Product Change Notification / RMES-02CRED041

CCB 4325 Final Notice: Qualification of MPHL as an additional final test site for selected Atmel ATSAM10Exxx and ATSAM11Exxx device families available in 32L VQFN (5x5x1.0mm) package.

CCB 4325
Pre and Post Change Summary
PCN #: RMES-02CRED041

Tray – No change

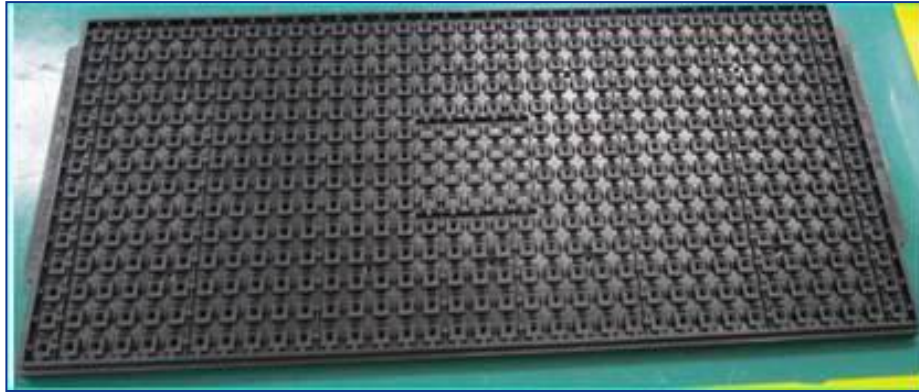
of Rows : 14
of Columns: 35
Pocket on Tray: 490 (BQM)
Tray Stack: 10 + 1 (10 + Cover)
Bakeable

of Rows : 14
of Columns: 35
Pocket on Tray: 490 (BQM)
Tray Stack: 10 + 1 (10 + Cover)
Bakeable

Tray Packing Procedure – No change

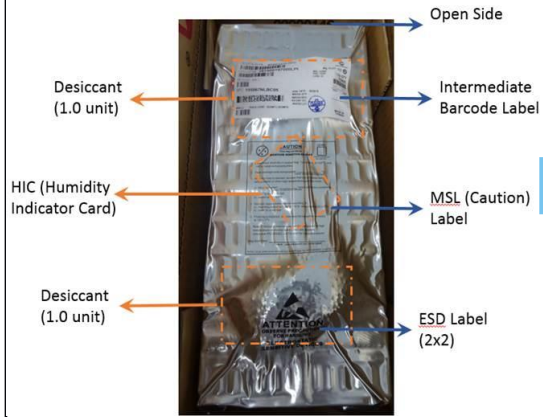
TRAY BUNDLING:
3 straps crosswise & 1 lengthwise
Max: 10 full trays + 1 empty tray cover

TRAY BUNDLING:
3 straps crosswise & 1 lengthwise
Max: 10 full trays + 1 empty tray cover

Tape and Reel - Carrier Tape – No change

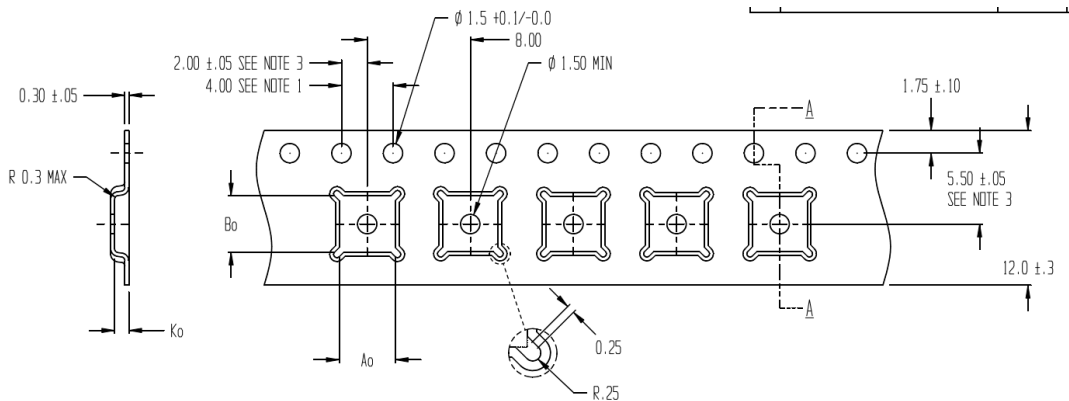
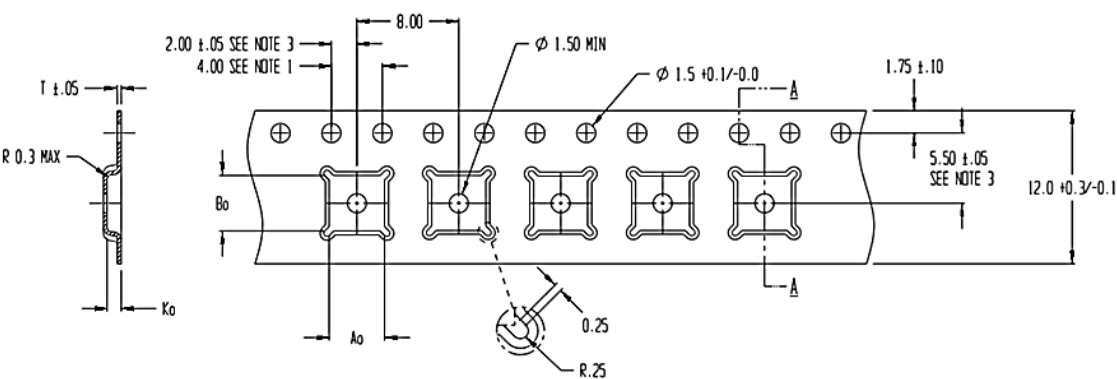
Width (mm)	Pitch (mm)	A0 (mm)	B0 (mm)	K0 (mm)	Thickness (mm)
12	8	5.25	5.25	1.10	0.30

Width (mm)	Pitch (mm)	A0 (mm)	B0 (mm)	K0 (mm)	Thickness (mm)
12	8	5.25	5.25	1.10	0.30

Tape and Reel – Packing Procedure – No Change

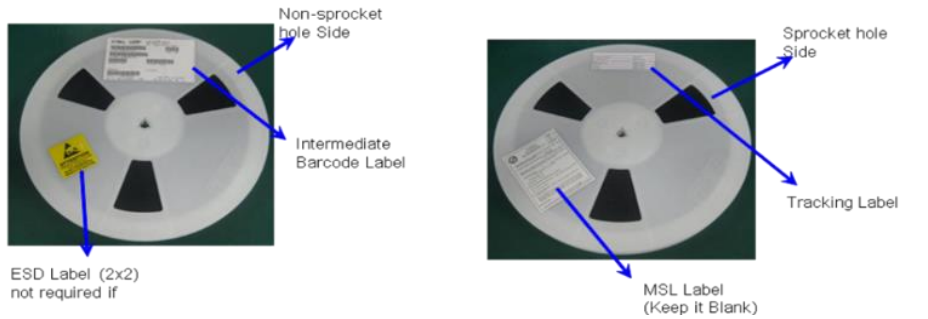
Label Placement at Box

Label Placement at Box
